PREVOST

Warranty Bulletin

95-36A

Date: **January 1996**
Section: **03**
Subject: **SUCTION TUBE ON POLYETHYLENE FUEL TANK**
Revision A:

FIGURE 1: MODIFICATION OF ENGINE SUCTION TUBE IN FUEL TANK

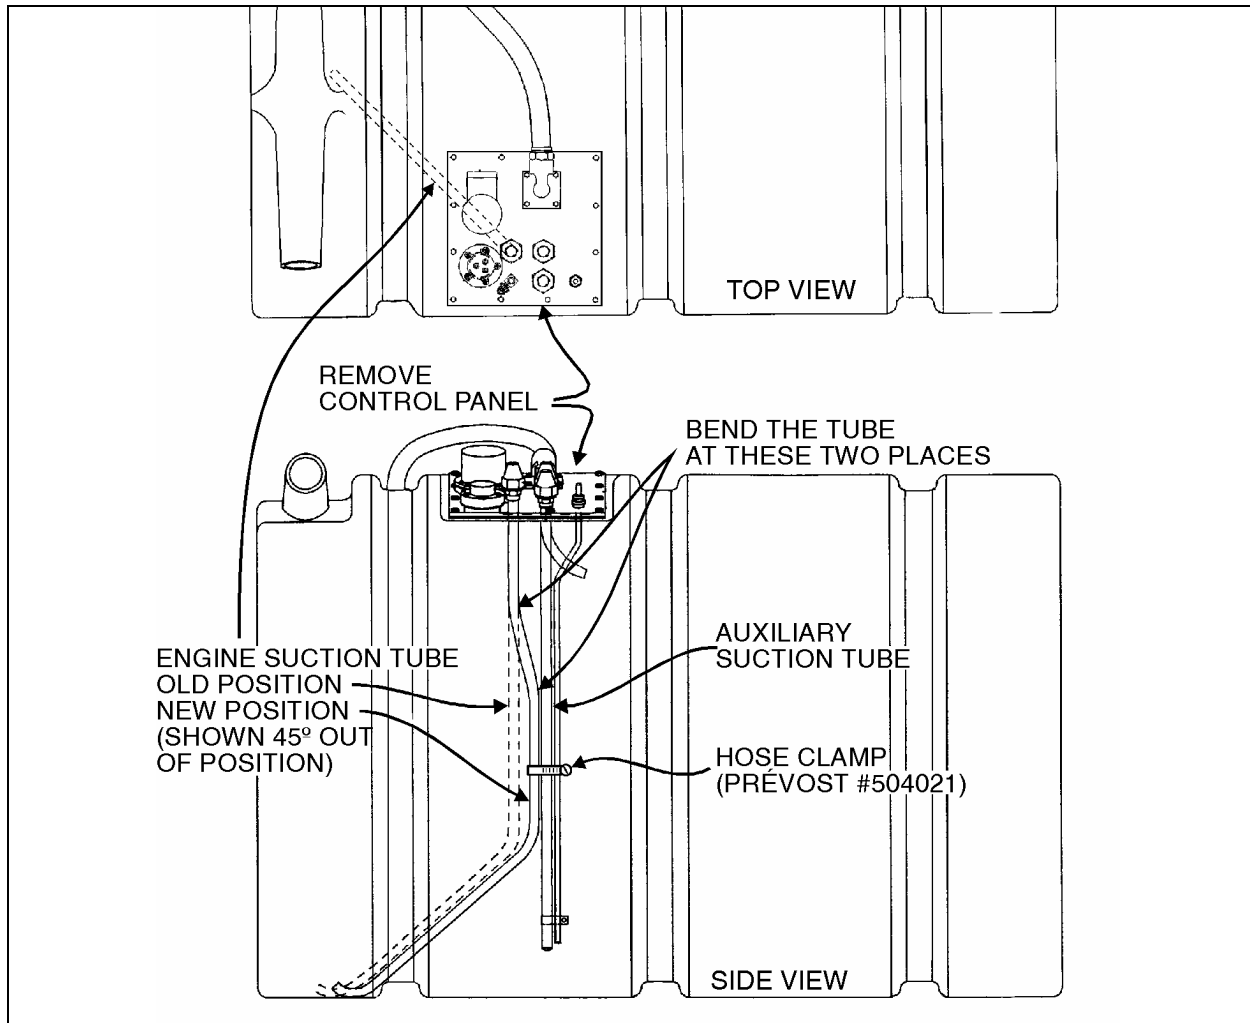
Modification on figure 1

On the H3 Series vehicles, it is possible that a failure happens on the engine suction tube on the polyethylene fuel tank. To prevent this failure to happen, we recommend that you perform the modifications described in this bulletin.

3. Bend engine suction tube on auxiliary suction tube as shown on figure 1.
4. Install hose clamp on both engine and auxiliary suction tube (Prévost #504021) (Fig. 1).
5. Using new seal and new copper washers (Prévost #032014 and #505512), replace and fix fuel tank control panel.
6. Replace and fix fuel tank access panel.
